September 11, 2015

Subject: Case Closure Denial, Additional Site Investigation Needed for
Block System Cleaners, 2017 Winnebago Street, Madison, Wisconsin
DNR BRRTS Activity # 02-13-552132

On Wed, Jul 29, 2015 at 11:02 AM, <janet.dimaggio@wi.gov> wrote:
This email confirms on 07/21/2015 the Wisconsin Department of Natural Resources (DNR) Remediation and Redevelopment (RR) Program received Case Closure - GIS Registry Form 4400-202 (R 03/15) with fee(s) for:

02-13-552132 BLOCK SYSTEM CLEANER
2017 WINNEBAGO ST, MADISON

B.1.a Location Map
 Block System Cleaners Property
 2017 Winnebago Street
 Madison, Wisconsin

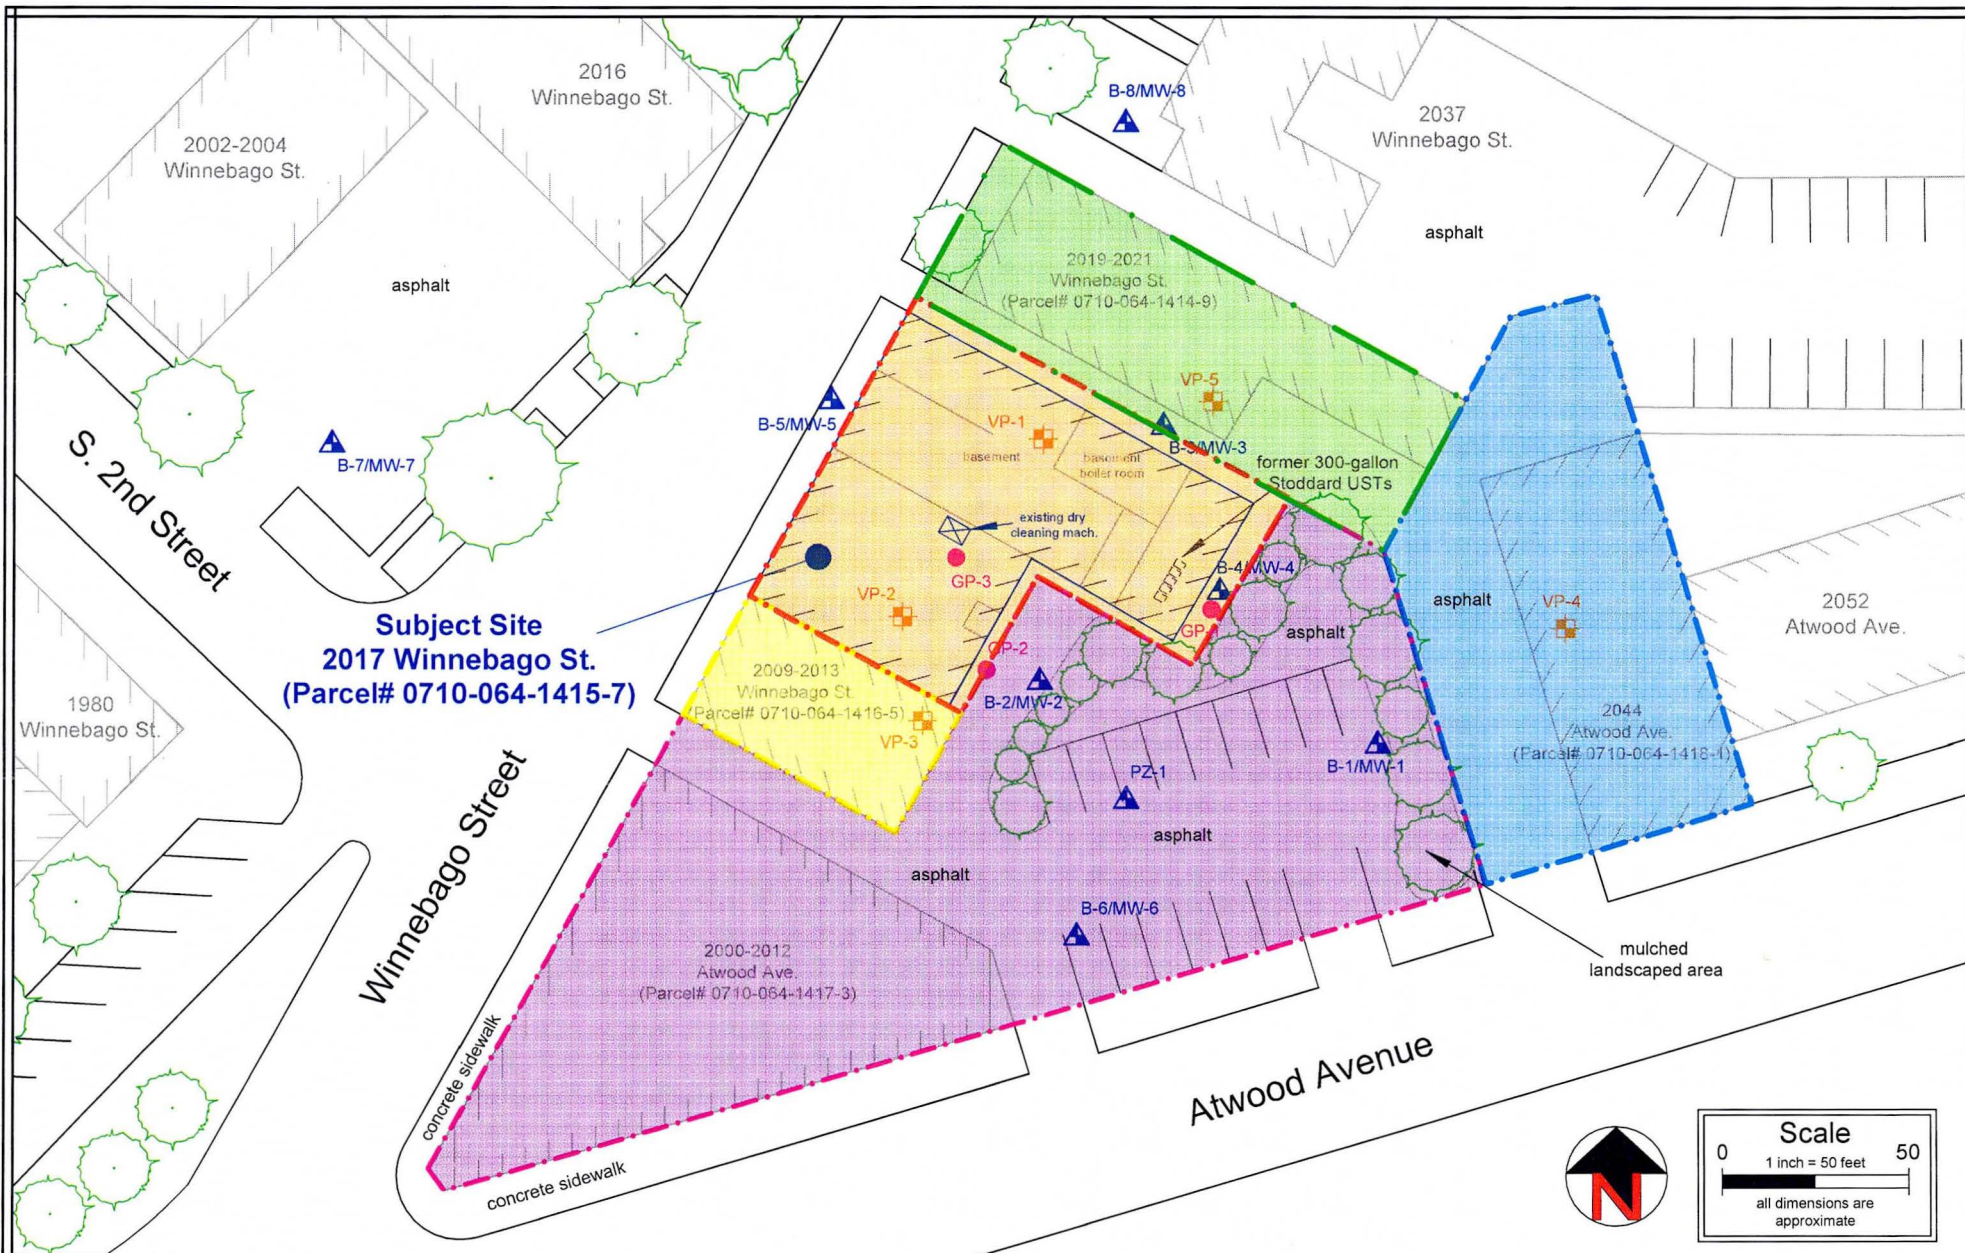
(Attachment B)(1A): Location Map

PM Comment: The map needs to "outline all properties within the contaminated site boundaries..."

B.1.b.1 Detailed Site Map with Affected Property Boundaries
Block System Cleaners
2017 Winnebago Street
Madison, Wisconsin

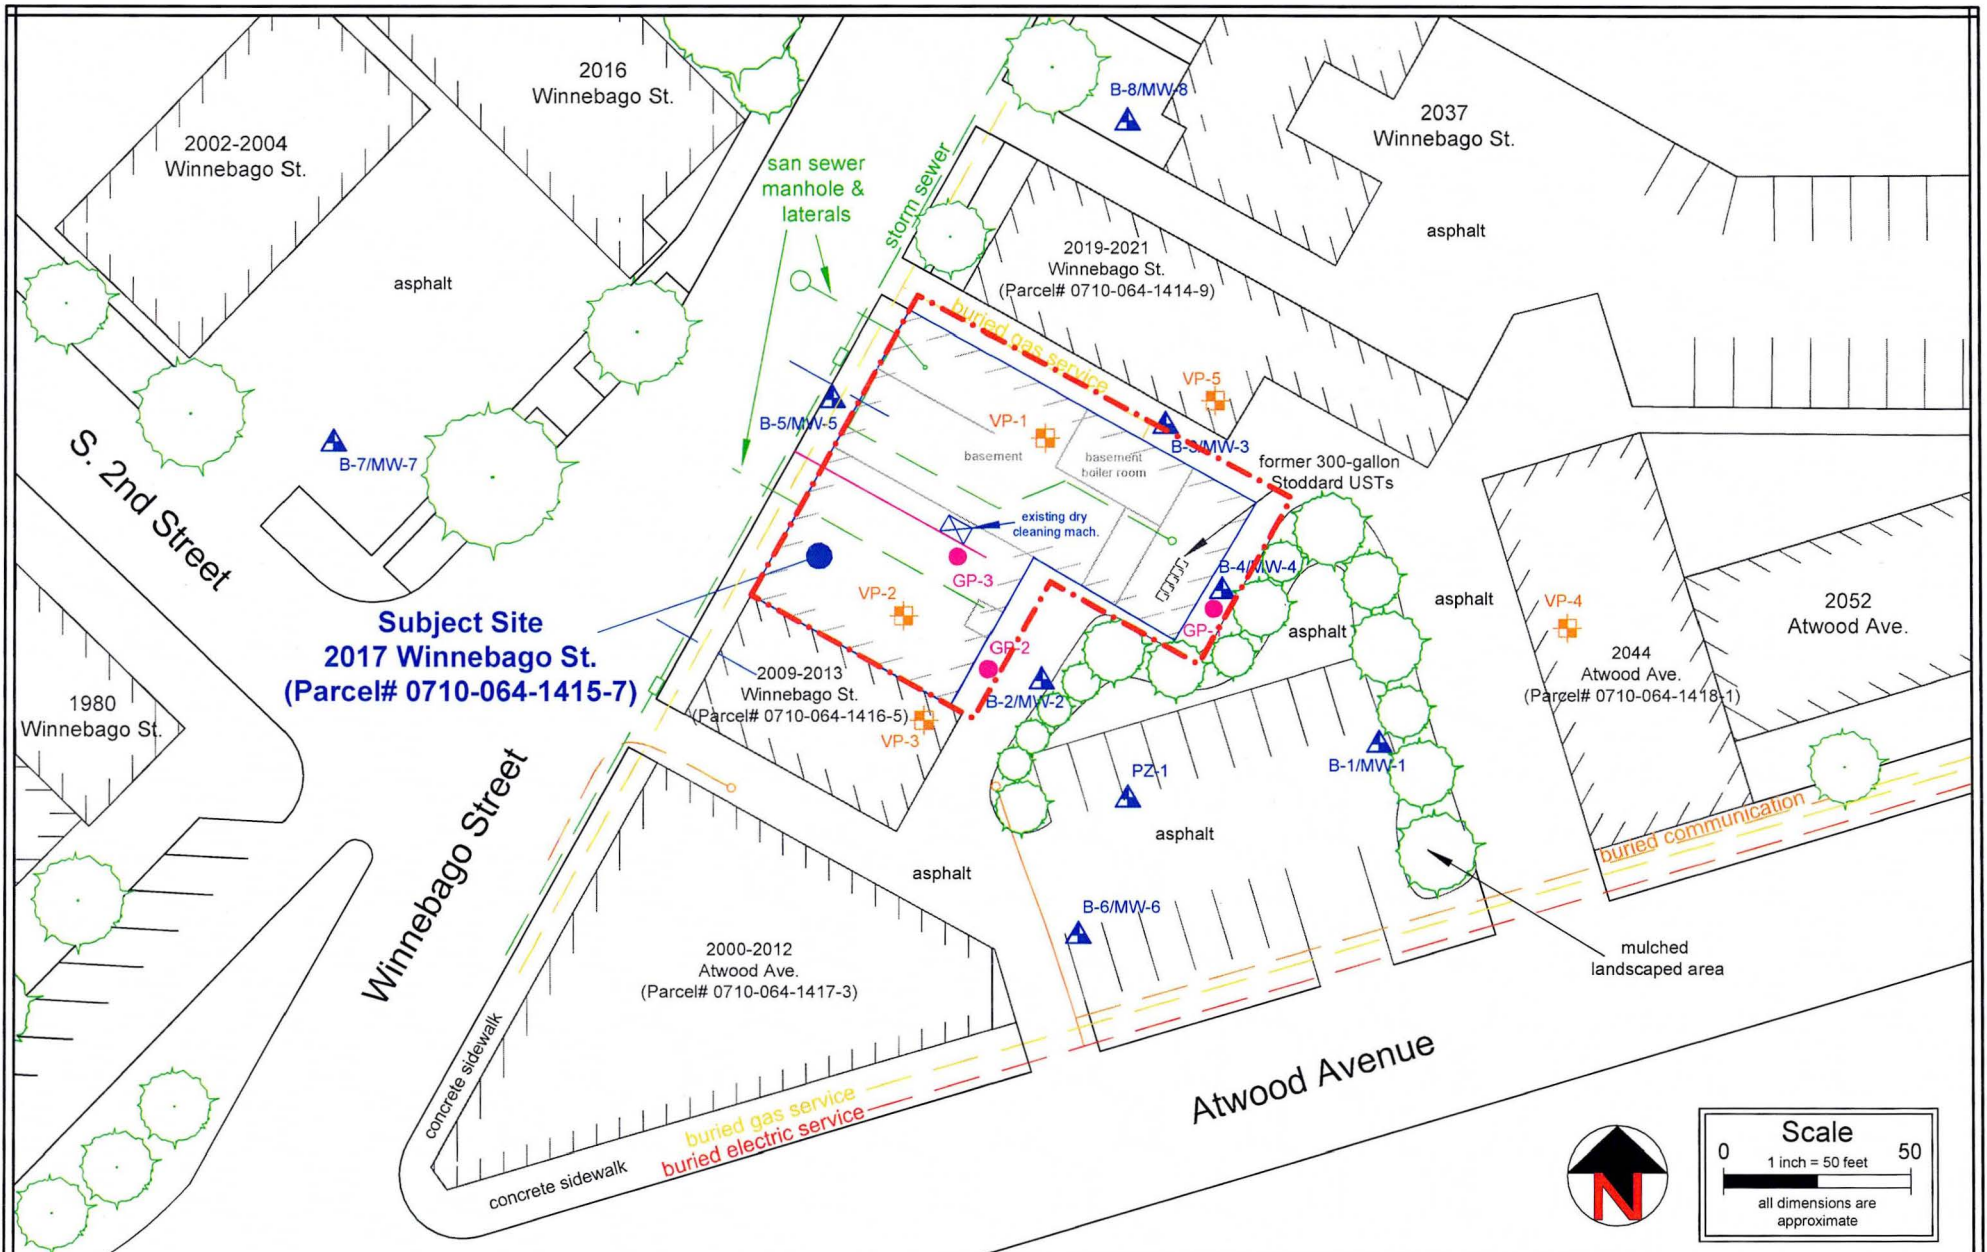
(Attachment B)(1B): Detailed Site Map

PM Comment: Property boundaries are not clearly indicated.

B.4.a Vapor Intrusion Map
 Block System Cleaners
 2017 Winnebago Street
 Madison, Wisconsin

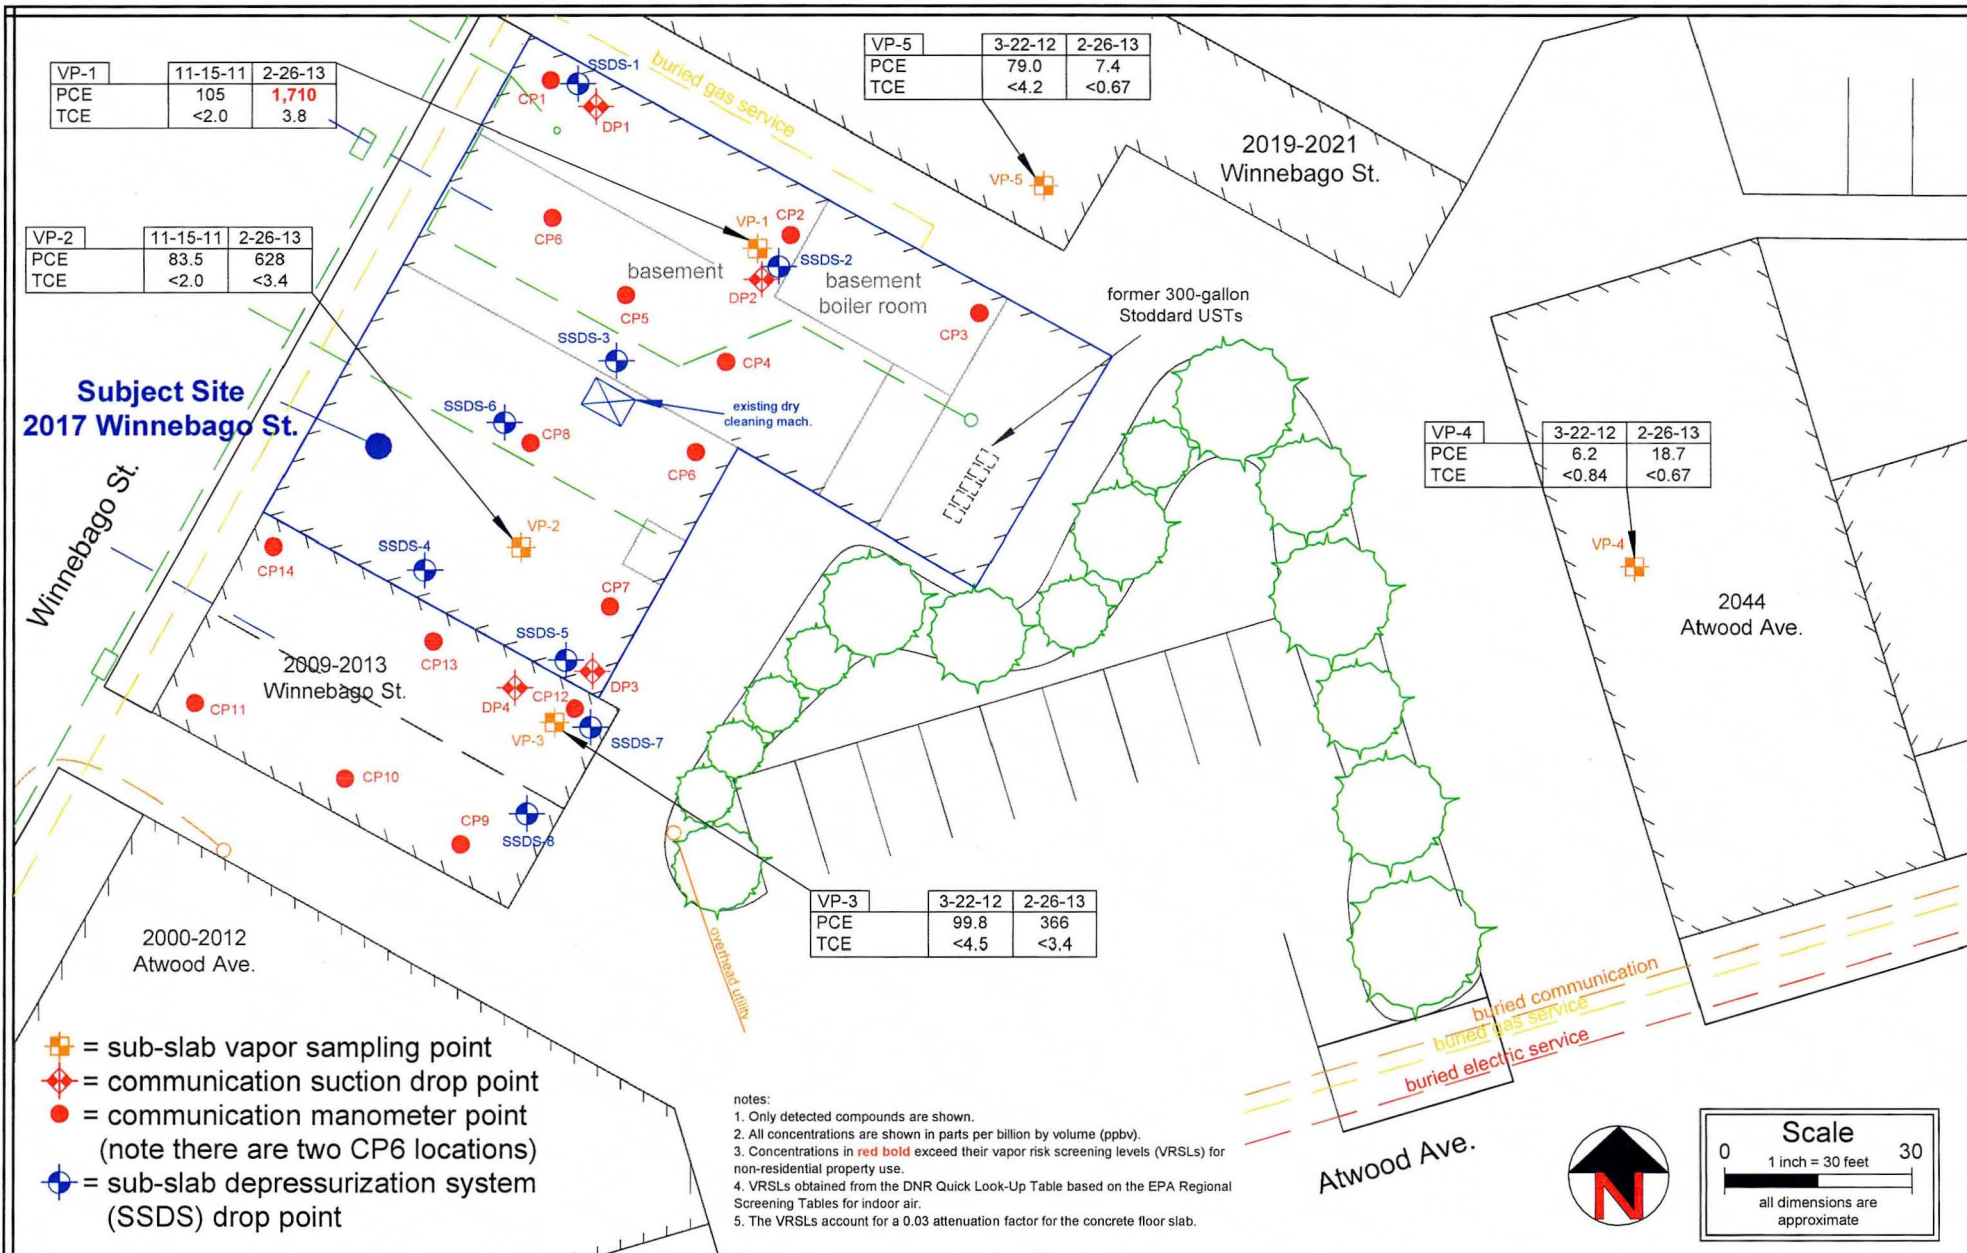
(Attachment B)(4A): Vapor Intrusion Map

PM Comment: Results of sampling should be noted on this map.

VP-1	11-15-11	2-26-13
PCE	105	1,710
TCE	<2.0	3.8

VP-5	3-22-12	2-26-13
PCE	79.0	7.4
TCE	<4.2	<0.67

VP-2	11-15-11	2-26-13
PCE	83.5	628
TCE	<2.0	<3.4

VP-4	3-22-12	2-26-13
PCE	6.2	18.7
TCE	<0.84	<0.67

VP-3	3-22-12	2-26-13
PCE	99.8	366
TCE	<4.5	<3.4
